NESBIT SITE

Response to DMS Comments – MY2 (2023)

Nesbit Stream and Wetland Mitigation Site, Union County
Catawba River Basin, Cataloging Unit 03050103
DMS Project ID No. 100121, Full Delivery Contract No. 7868, RFP No. 16-007704
USACE Action ID No. SAW-2019-00832, DWR Project No. 2019-0862

DMS Comments Received (Black Text) & Responses (Blue Text)

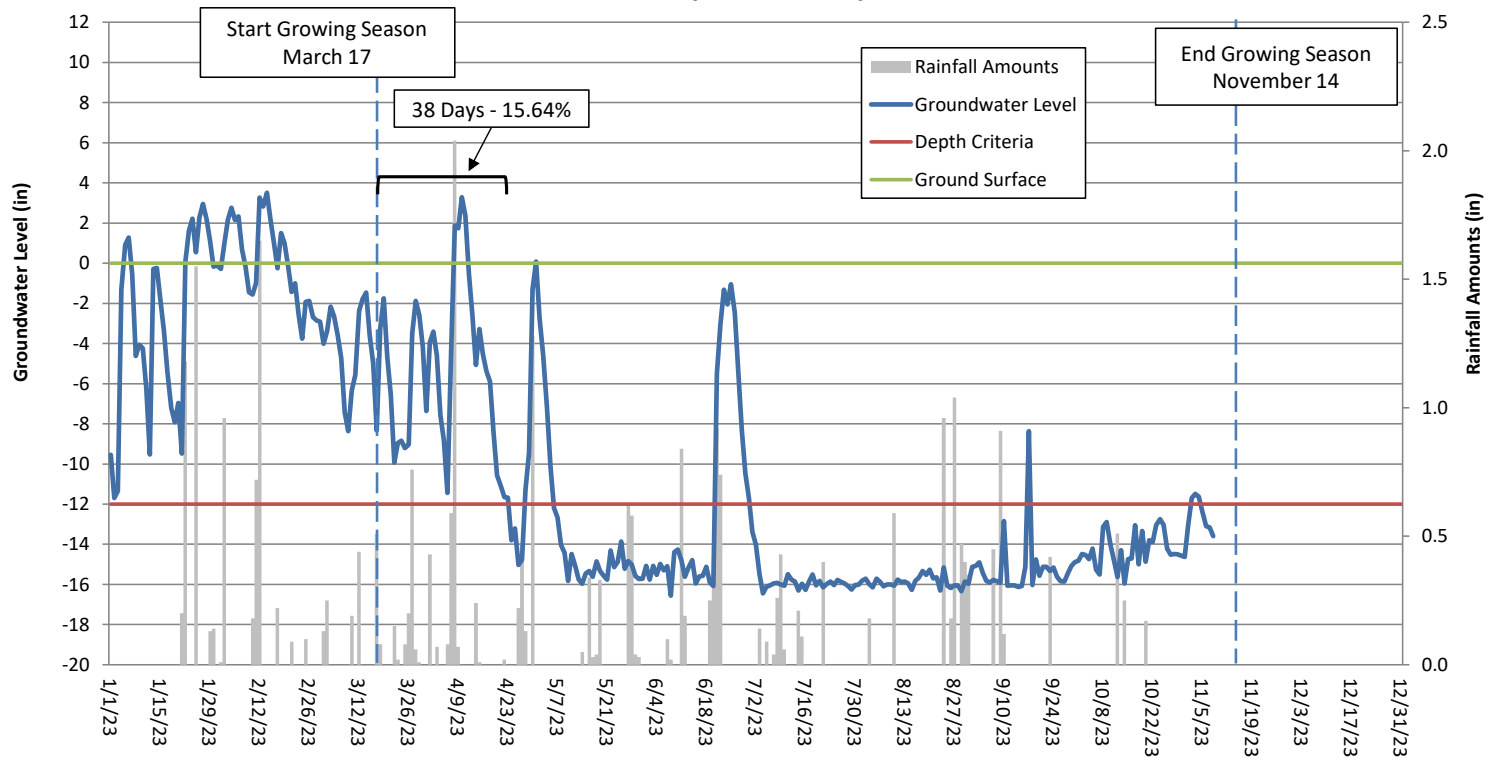
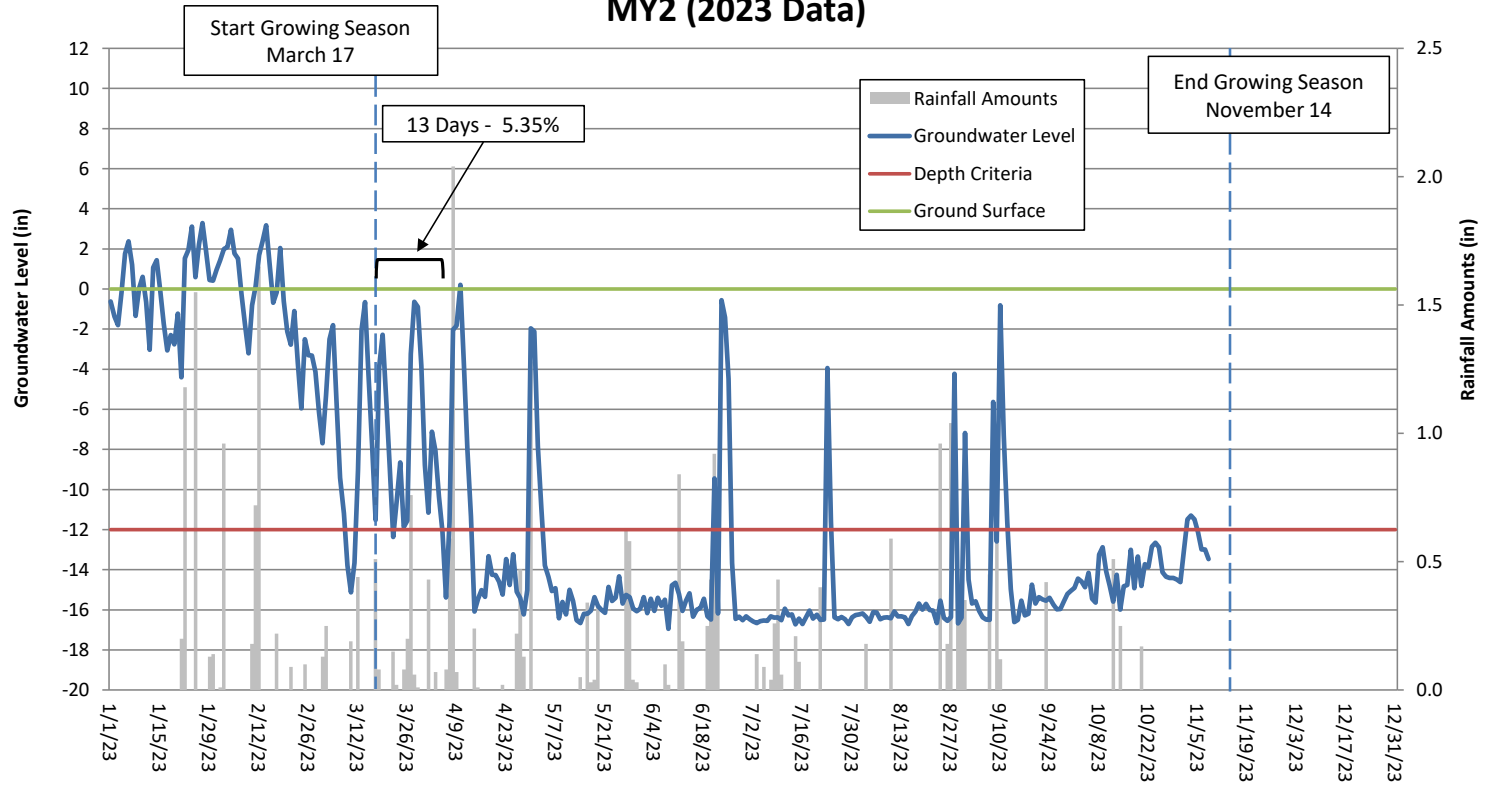
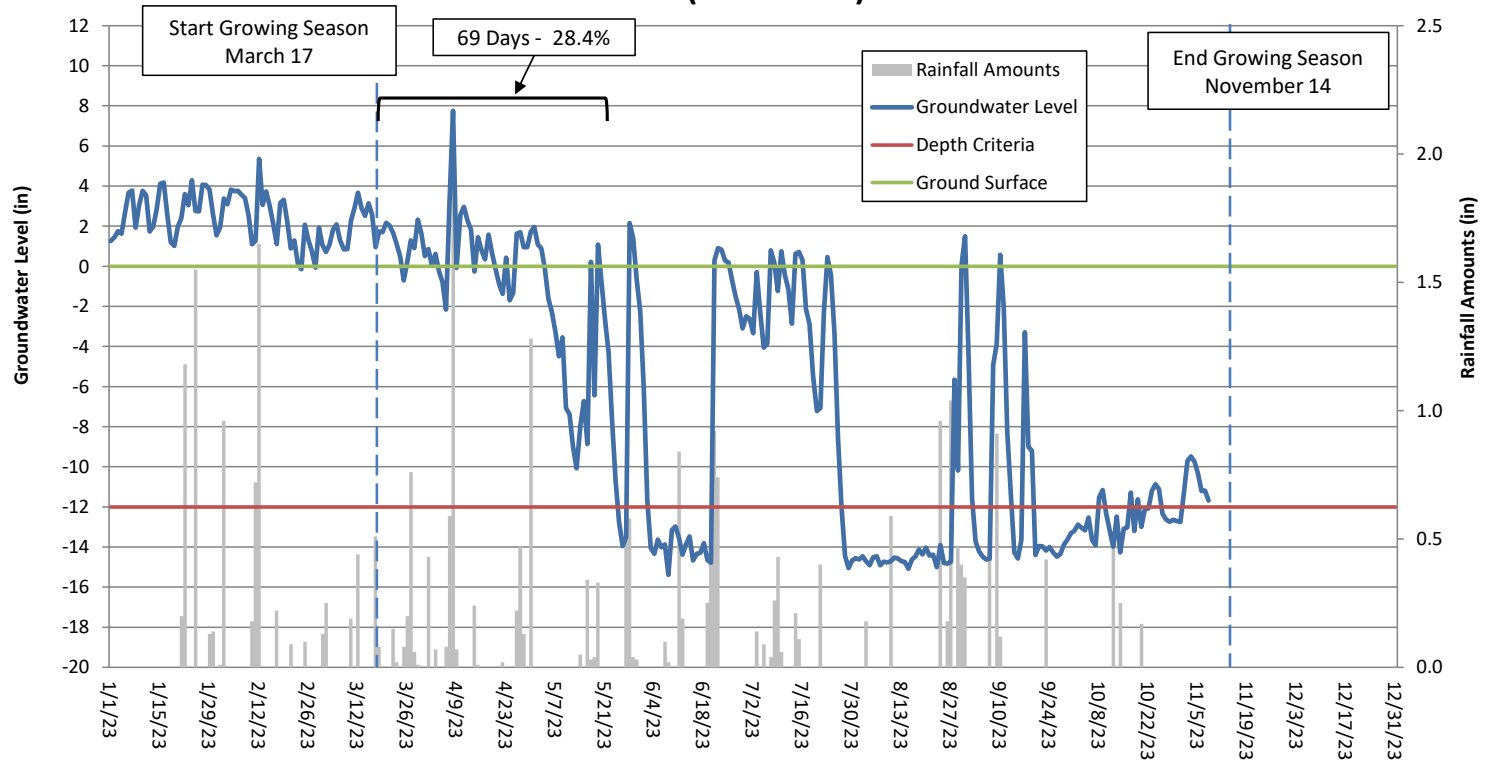
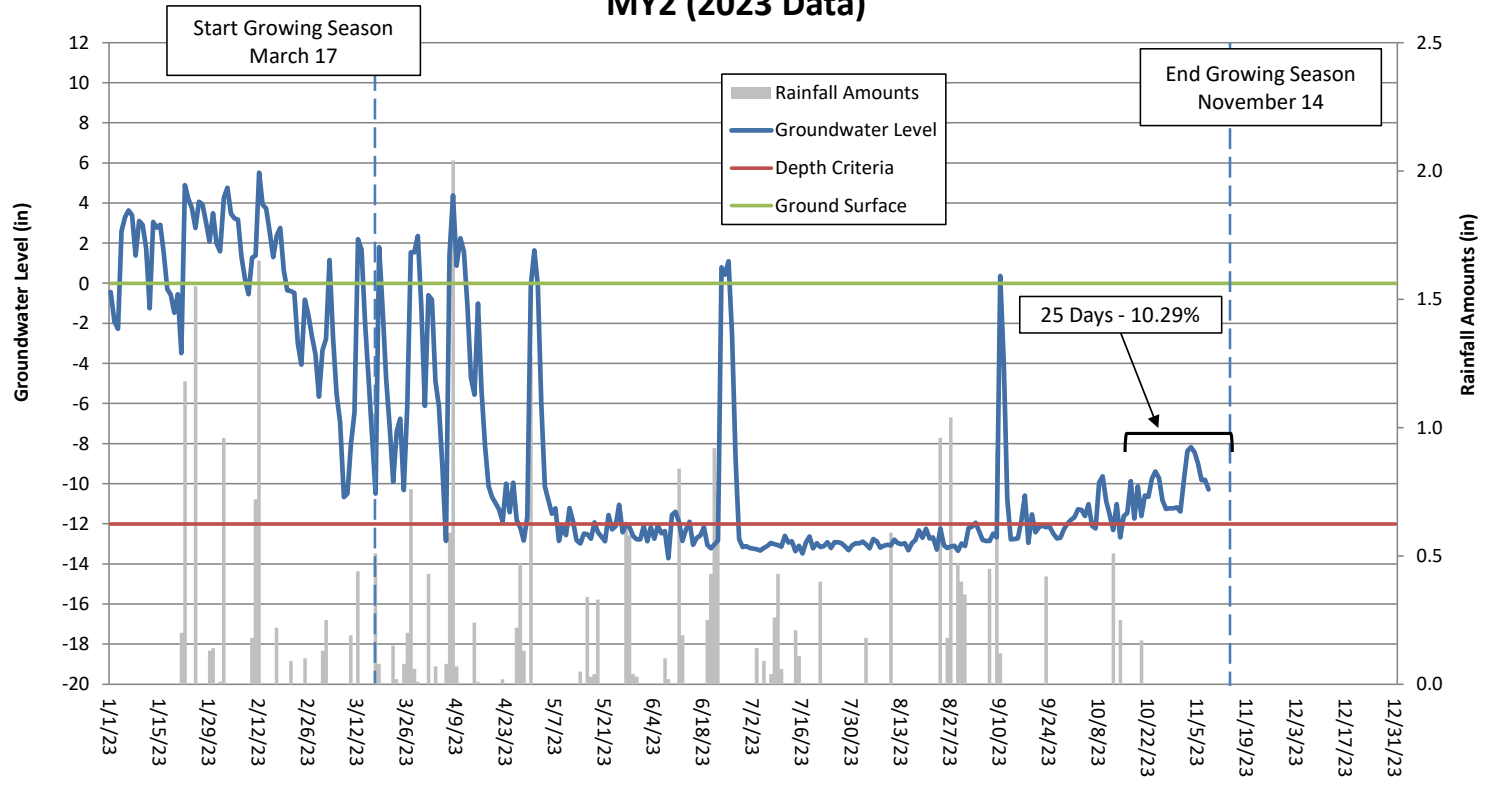
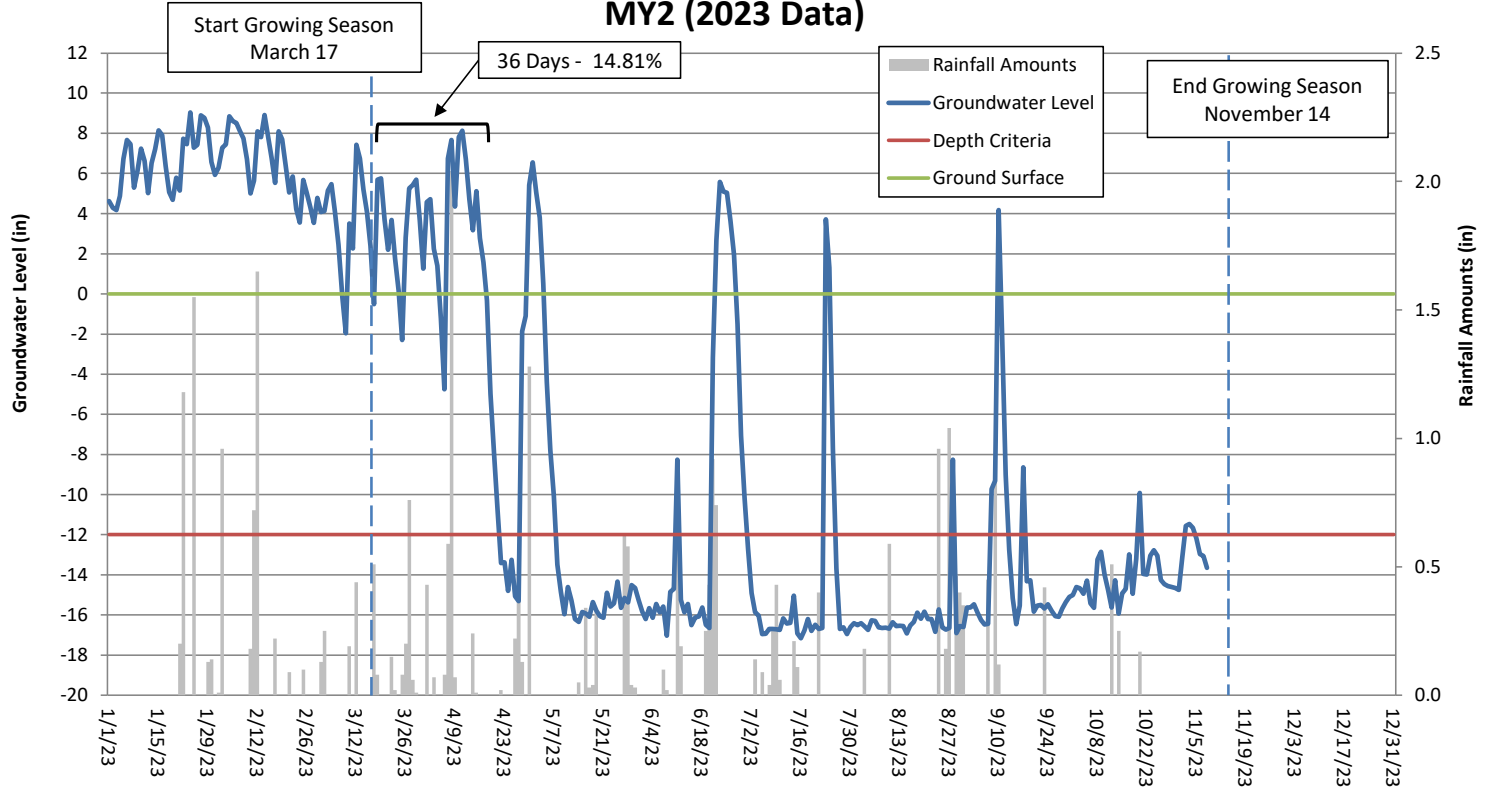
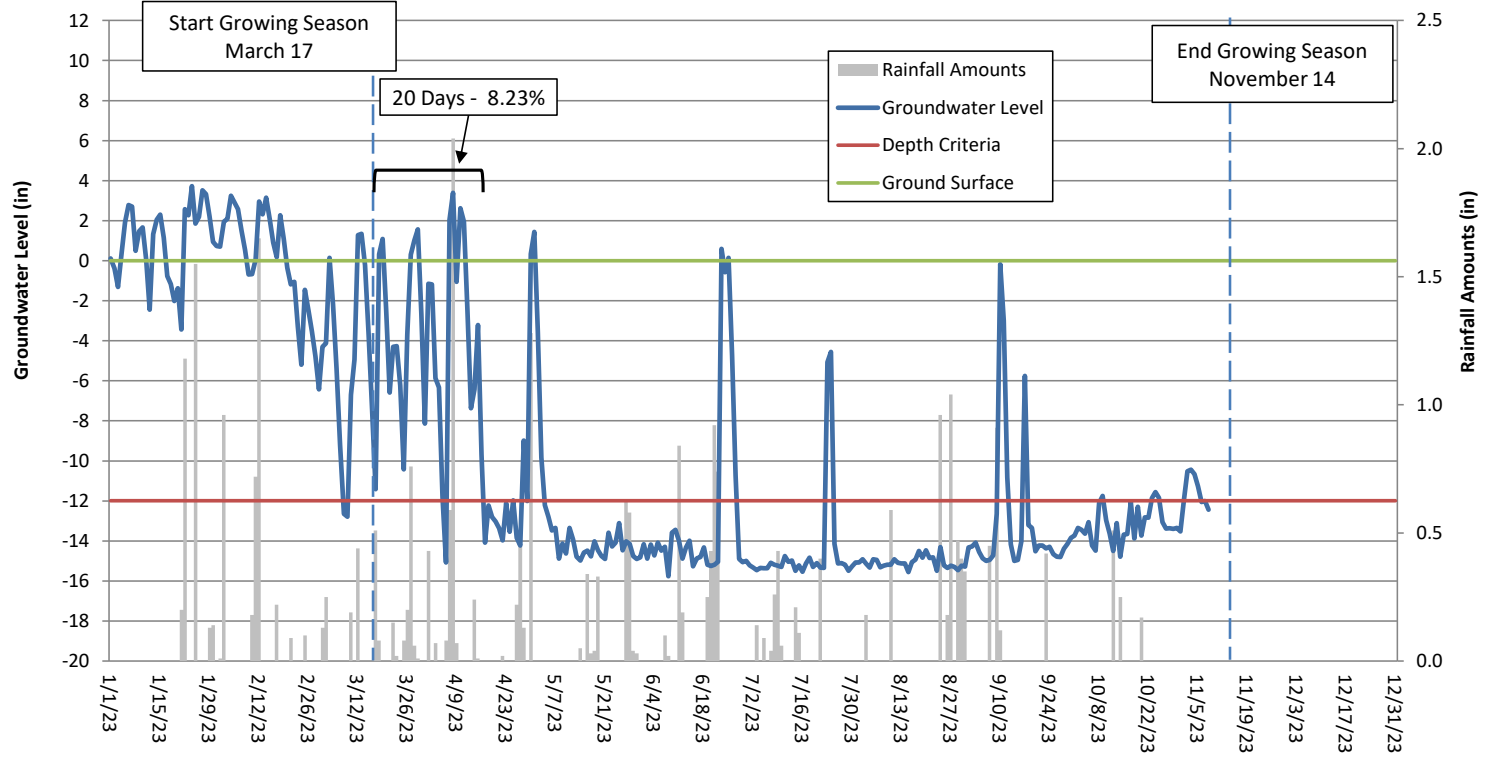
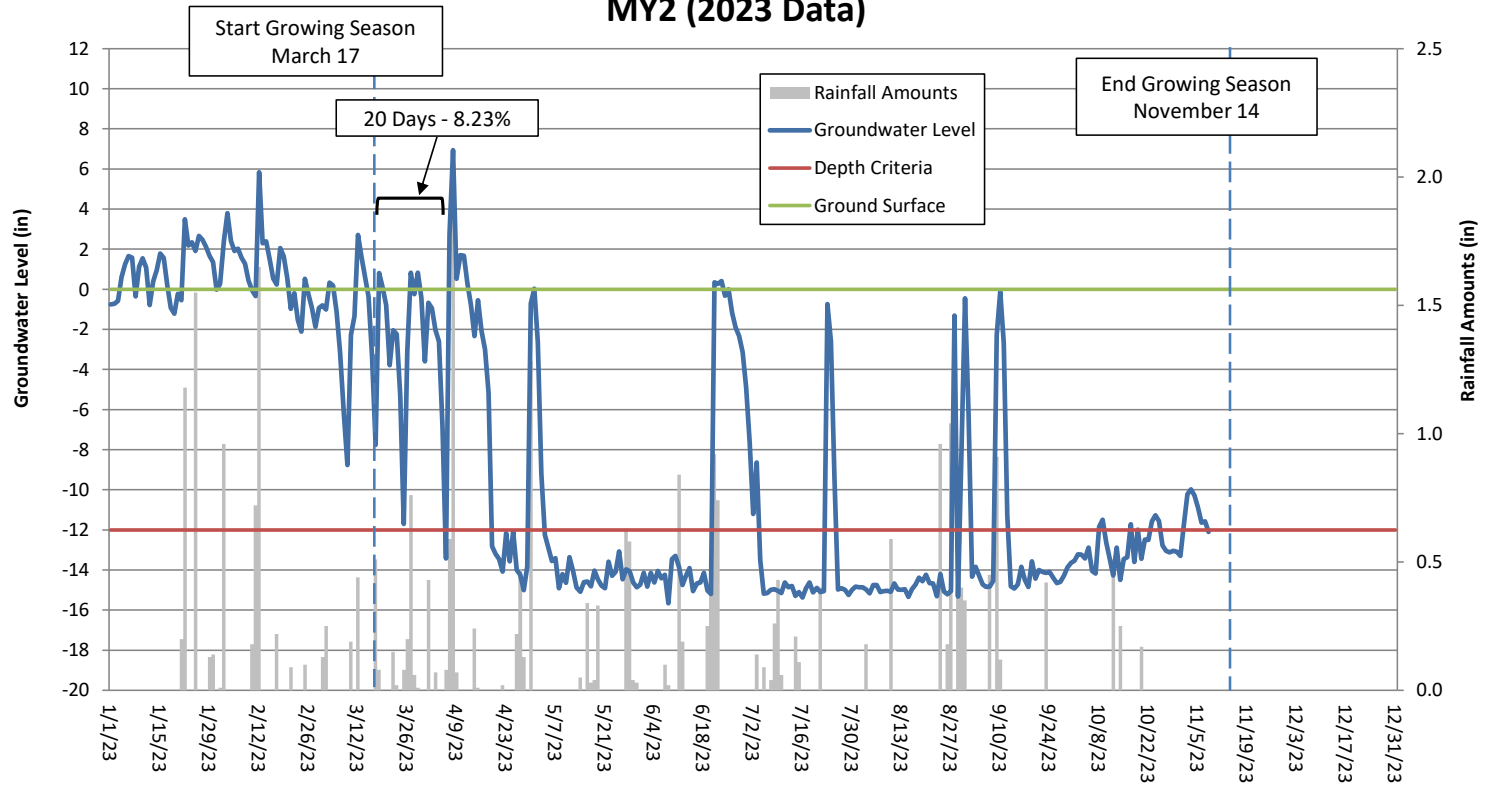
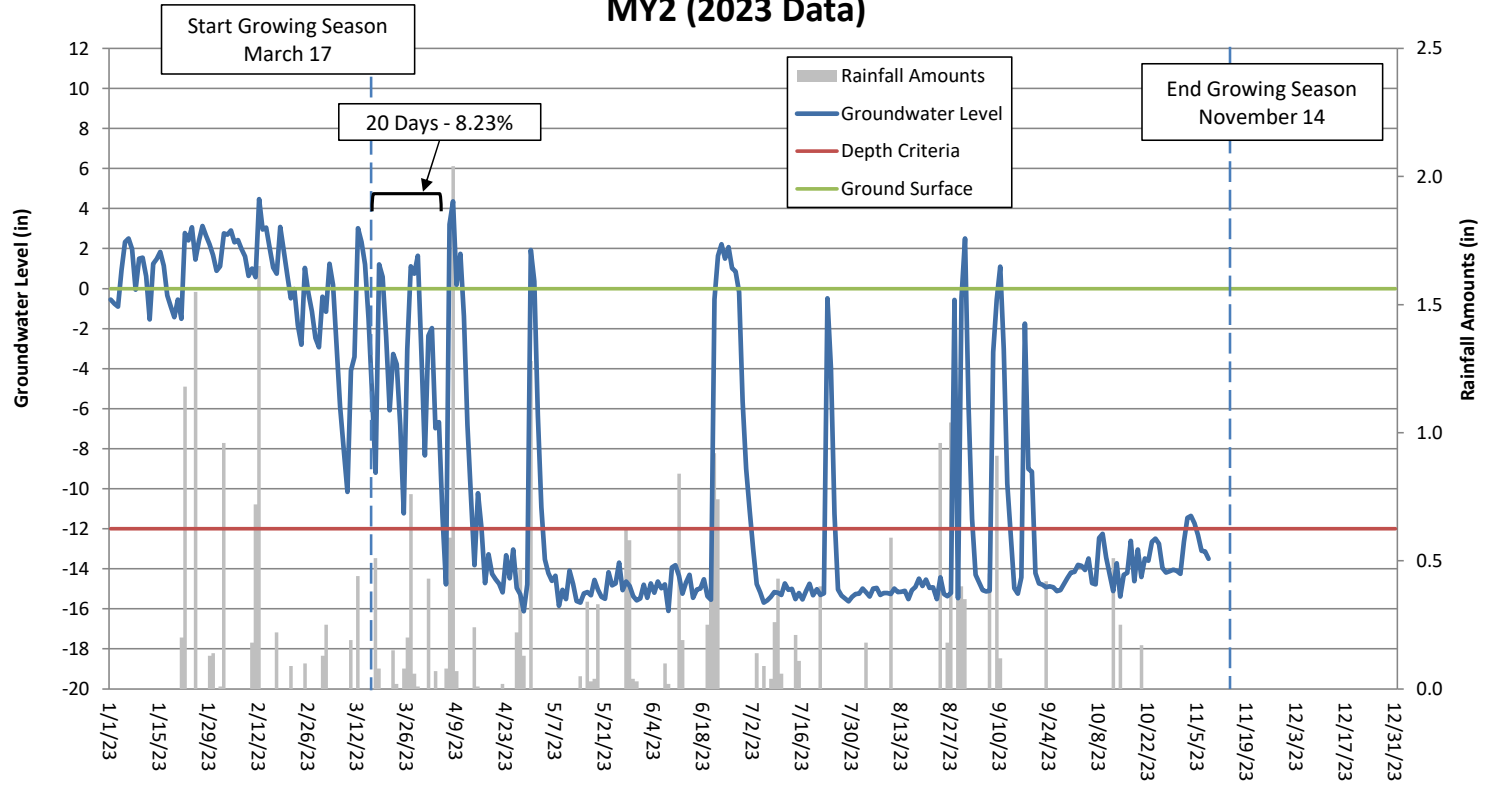
Response: Bankfull and thalweg elevations were added to the crest gauge graph. A legend was added to show each line type.
10. Appendix D. - Hydrologic Data - Nesbit Groundwater Gauge Charts 1-9: Add lines showing the ground surface and brackets showing the total number of consecutive days meeting the wetland criteria to the graphs. Add a legend showing each linetype/data point (precipitation, water level, depth criteria and ground surface).

Response: A ground surface elevation line, bracket for consecutive days meeting criteria, and legend were added to each groundwater gauge graph.
11. Appendix E, Table 14 - Project Timeline: Add all extra activities conducted at the site including supplemental boundary marking, soil amendment application and planting to the table.
